# Status of 802.1AS-Rev/D5.1 and Questions on Several Items Needing Resolution

## Revision 1

*IEEE 802.1 TSN TG*  
2017.11.08

Figure 11-37—Example negotiation and measurement exchange sequence for a single burst instance, ASAP=1, and FTMs per Burst = 3

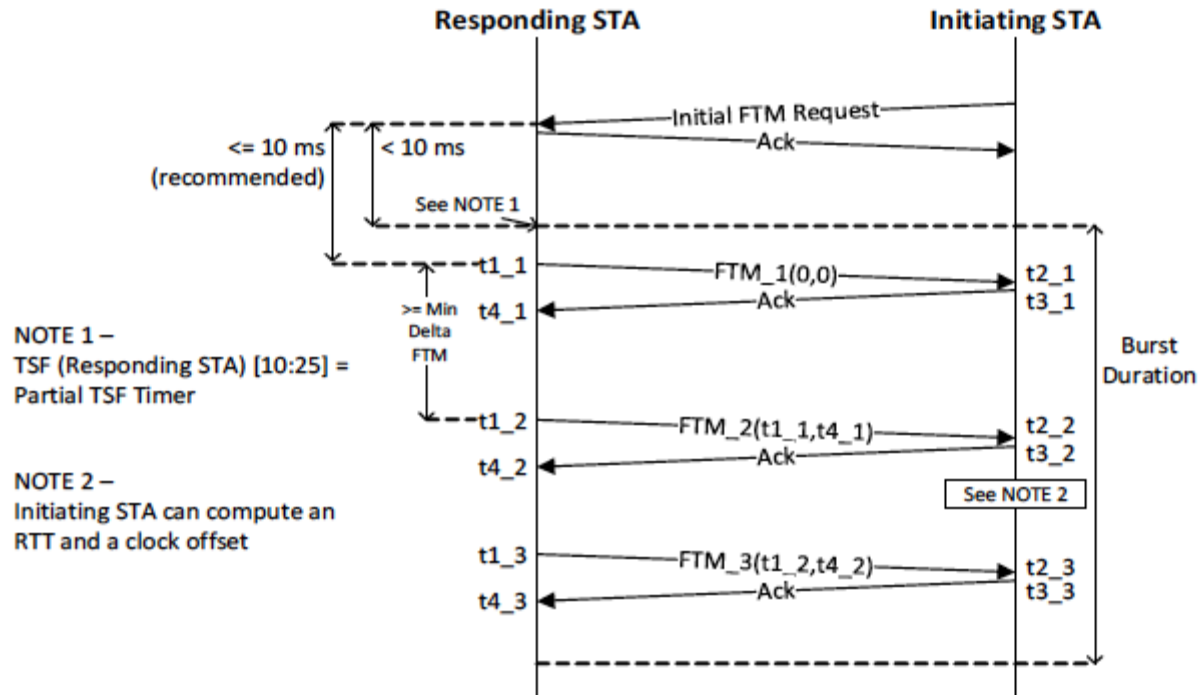
- The measurement exchange figures in 11.24.6.4 of 802.11-2016 (e.g., Figure 11-37) refer to the “Initial FTM Request”; related to this, comment #11 refers to an “iFTMR” that the Slave sends to the master

- However, 802.11-2016 describes only the MLME-FINETIMINGMSMTRQ.request; there is no “MLME-INITIALFINETIMINGMSMTRQ.request”
  - It appears the use of “Initial FTM Request” simply means that this is the first (or initial) FTM Request; it is not meant to be a different message or primitive from the FTM Request

- The editor would like to confirm (or at least clarify) this
  - Related to this, comment #11 refers to the master responding to the iFTMR with an iFTM after sending the ACK to the iFTMR

- However, the figures in 11.24.6.4 simply show normal FTM messages that follow the ACK (with each FTM having a corresponding ACK)
    - It appears that the iFTM is simply the first of these FTM messages

- The editor would like to confirm (or at least clarify) this

- ❑ It is assumed below that the exchange shown in the figure on the previous slide will be used for FTM in 802.1AS-Rev
- ❑ In addition, it is assumed that each session will contain a single burst as illustrated in this figure
- ❑ With these assumptions, we can begin to suggest values for various FTM parameters, on the following slides

□ From Figure 11-37 of 802.11 (shown on slide 11), which shows the message exchanges in the burst

$$\begin{aligned} & \text{2*(Min Delta FTM) + SIFS + TXTIME(FTM) + TXTIME(ACK) < Burst} \\ & \text{Duration} \end{aligned} \quad \text{Eq. (1)}$$

$$3*(\text{Min Delta}) < \text{Burst Duration} \quad \text{Eq. (2)}$$

$$10 \text{ ms} + \text{Burst Duration} < \text{mean Sync Interval} \quad \text{Eq. (3)}$$
